DESIGN REVIEW BOARD JUNE 19, 2020

DESIGN REVIEW BOARD SUMMARY APRIL 17, 2020

1. Dunkin Donuts DRB200015 700 North Main St

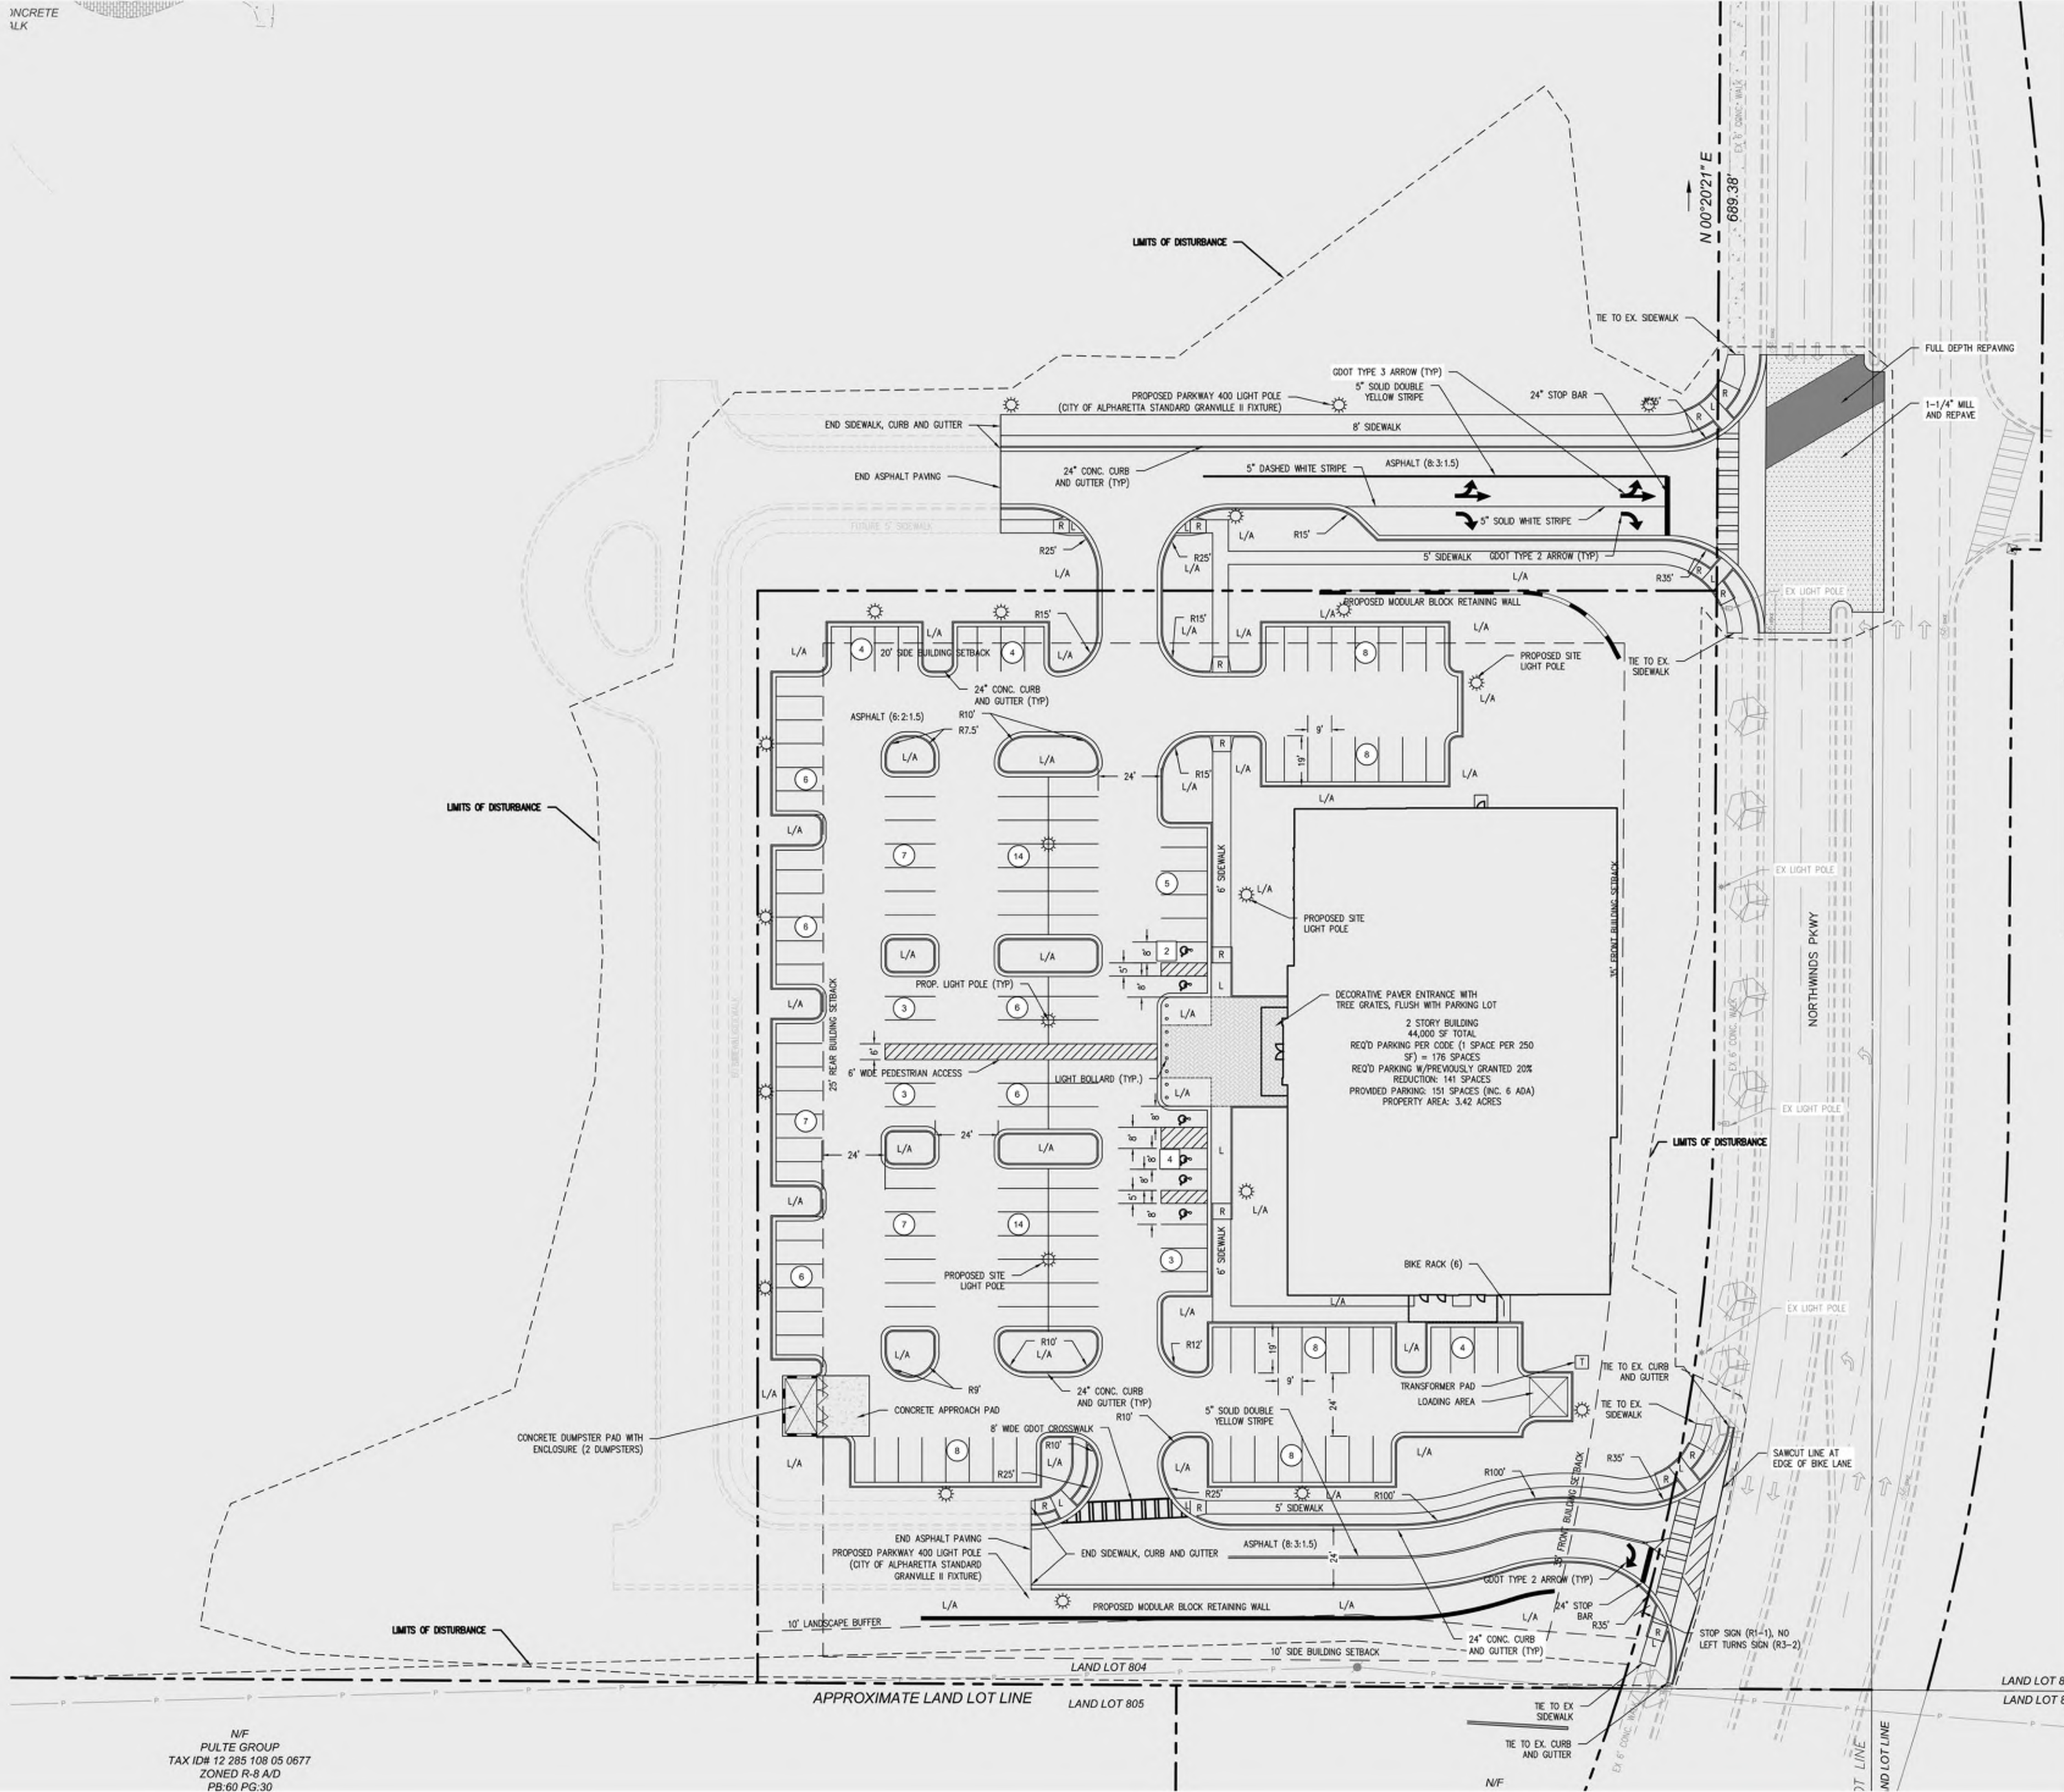
1. Request transformer be moved to other side of the building
2. Move location of dumpster
3. Size of buffer
4. Plantings in Buffer too sparse
5. Woods are sparse currently
6. Concern with light emanating from glass wall
7. Move Street Light on Right of Way to interior side of road
8. Power lines

- Site view angle study for that side
 - Staff stated only first 4 homes are the only ones that will be affected by this plan.
 - Staff Commented - Backside of property is more important view for now. Future plans will affect the rest of Braeden. Future development may have a larger buffer. This development received a variance to the buffer.
 - 15' maximum power line height.
 - New power lines will be underground
 - Corkill asked - on North side of wall. Could that be thick row of trees such as Magnolia or Arborvitae?
 - West side landscaping can't just come down and meet the buffer due to future road.
- ❖ Board Member Schwing offered a motion to defer the application
 - The motion received a second from Board Member Palmer
 - The motion was approved by a vote (7-0)

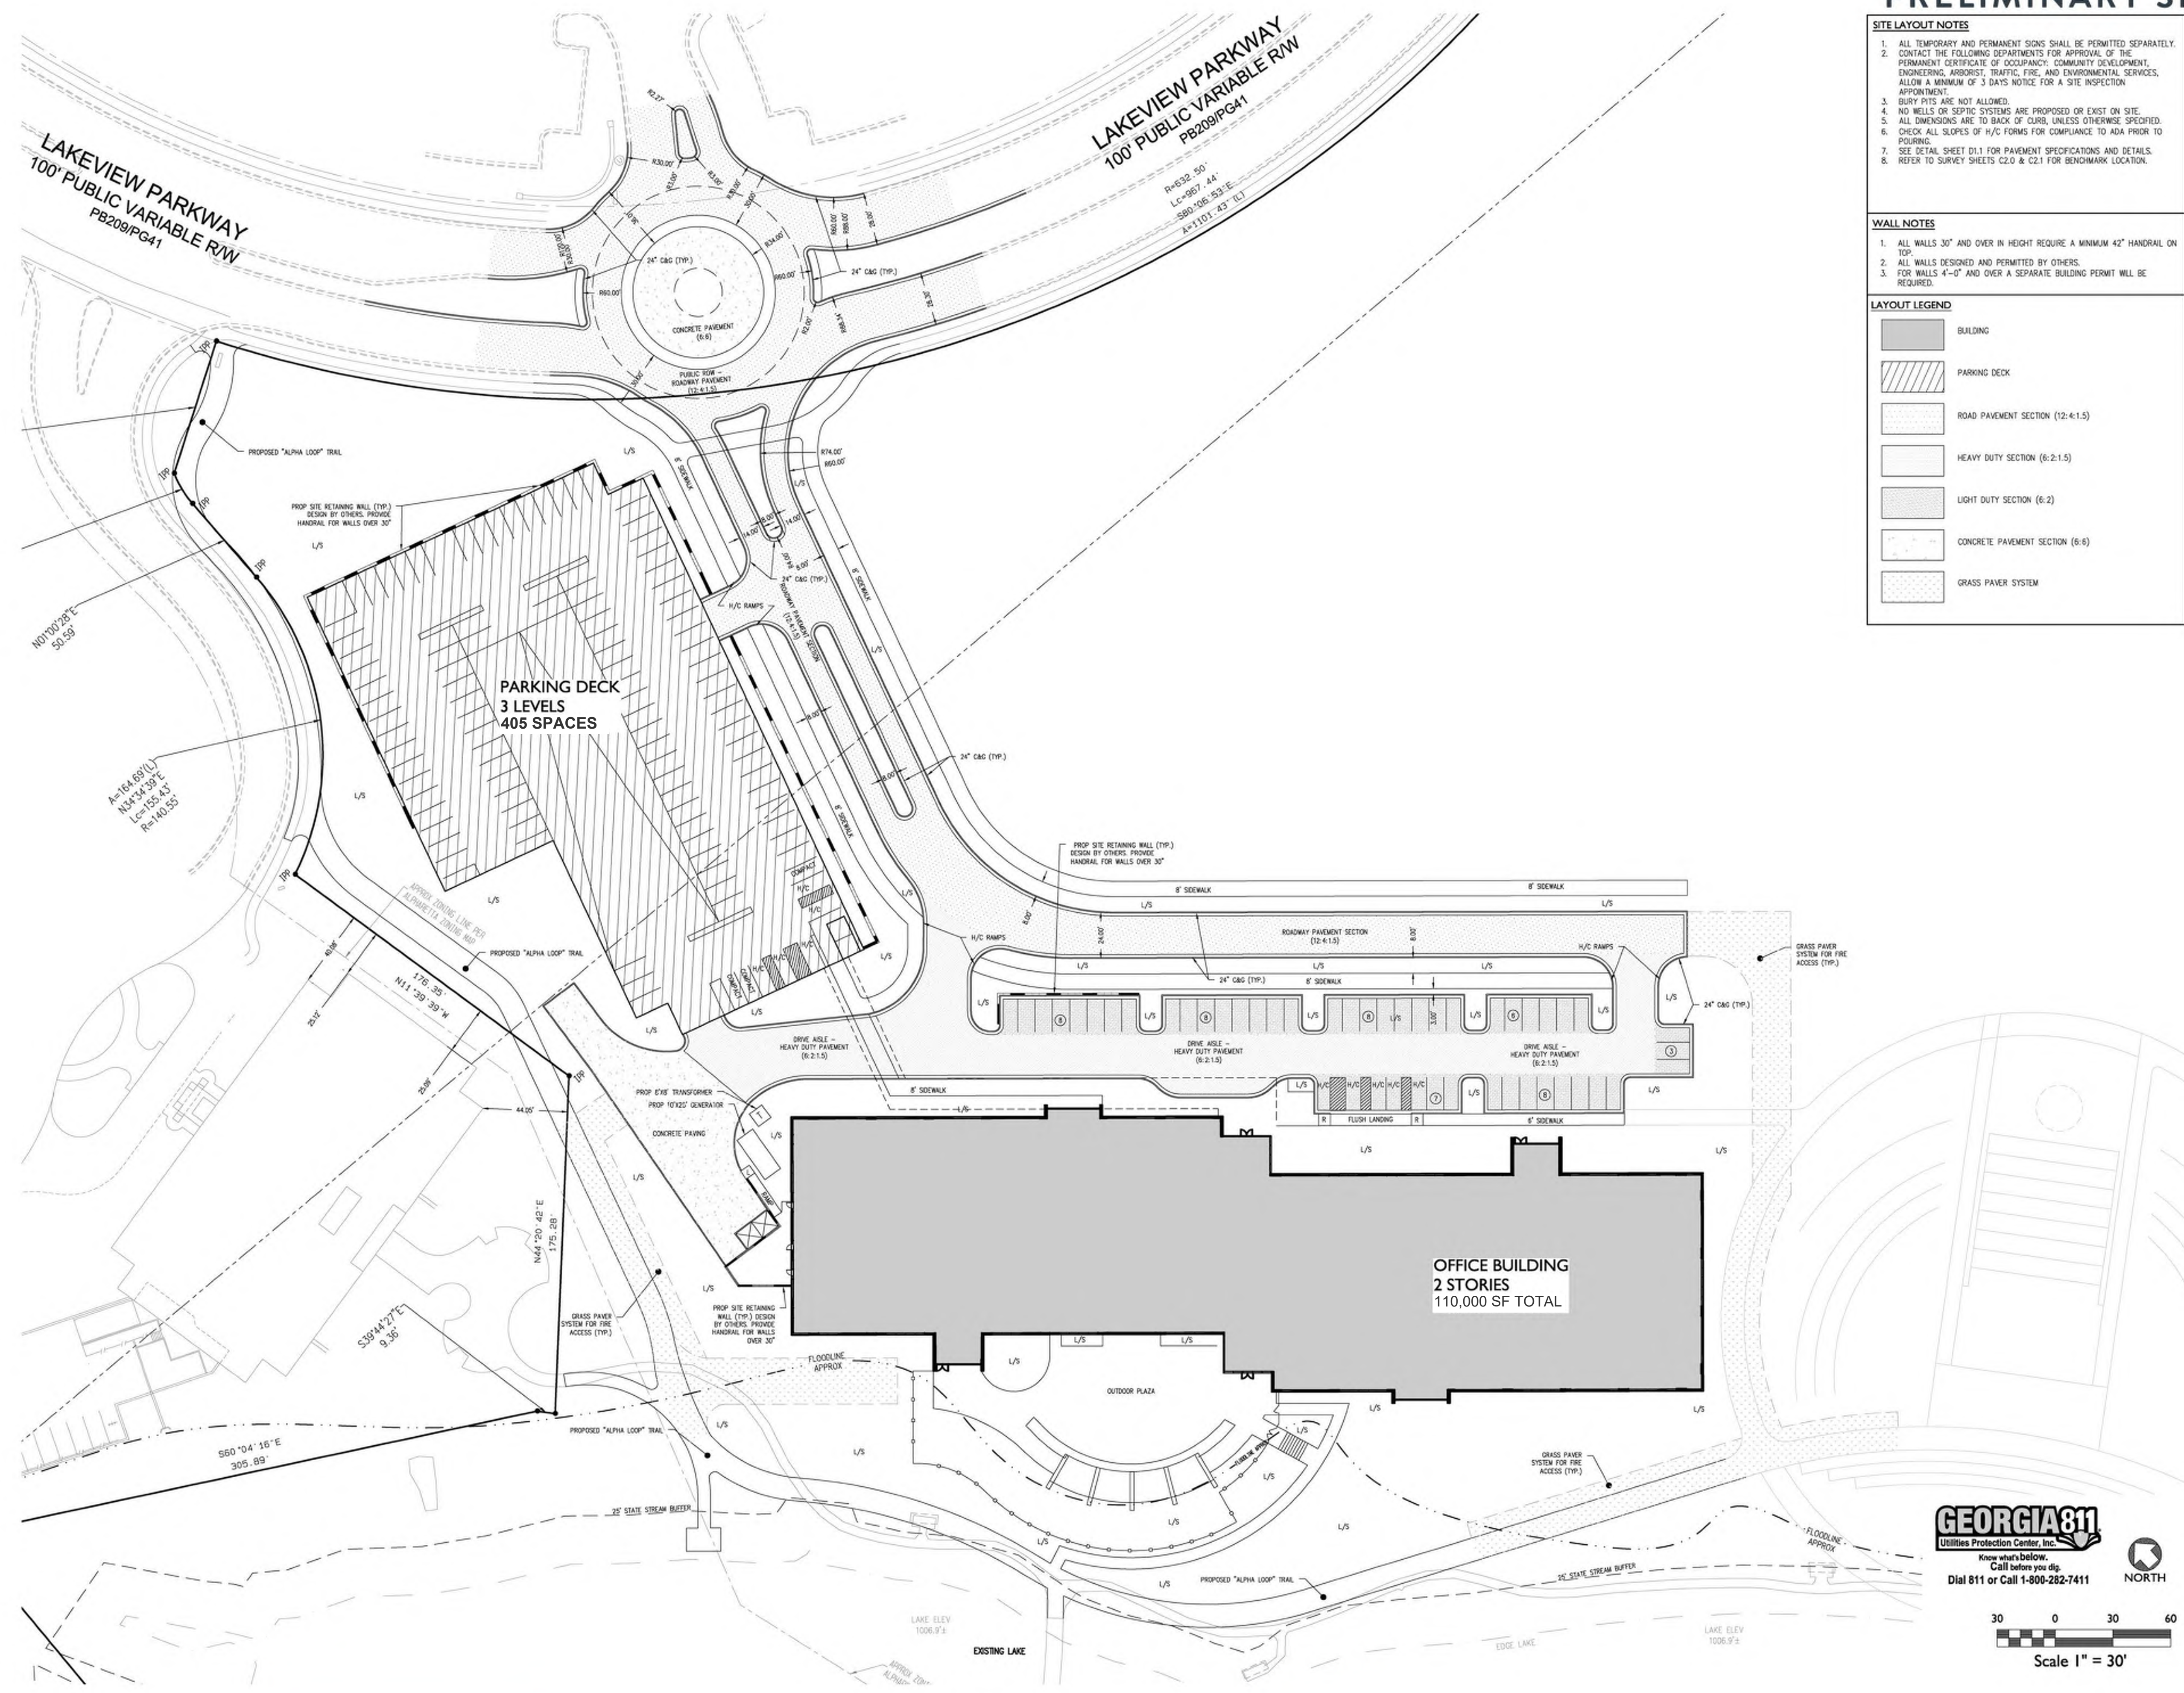
There was discussion during the motion that the illustrations did not match the plan.
Plan view needs

There was more discussion on concrete vs. cement panels. Board Member Schwing asked for clarification on the difference architecturally. DRB needs to see color and finish.

- ❖ Board Member Schwing offered a motion to approve Elevations and Materials as presented today with the condition that Applicant submit a sample of concrete sample to Staff for approval.
- The motion received a second from Board Member Palmer
- The motion was approved by a vote (7-0)
